# APPROVAL FOR CONSTRUCTION

THE PLANS AND SPECIFICATIONS FOR SEWAGE OR WASTE DISPOSAL SYSTEM SUBMITTED FOR:

APPROVAL # 134827

PLAN OF PROPOSED SEPTIC SYSTEM

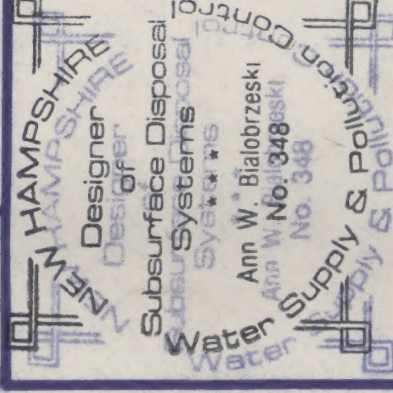
NOTE: ( X ) Gravity system ( ) Gravity system to septic tank and effluent pump chamber with disposal system to be constructed on a properly prepared base.

Bed bottom to be set: ( ) no deeper than " below the original grade  
( X ) no less than 32 " above the original grade  
( ) no lower than the original grade

to maintain ( X ) 4 ' minimum above (the reported) (any) seasonal high water table.  
( ) ' minimum above (the reported) (any) ledge depth.  
( ) ' minimum above (the reported) (any) impermeable soil.

( X ) Fill to prepare disposal area should be a medium to coarse sand (0.5 to 1.0 mm).  
( ) This approval only valid for the above owner's domicile/exemption.

CONDITIONS: Foundation drains are not permitted. Installation of foundation drains shall void this approval.
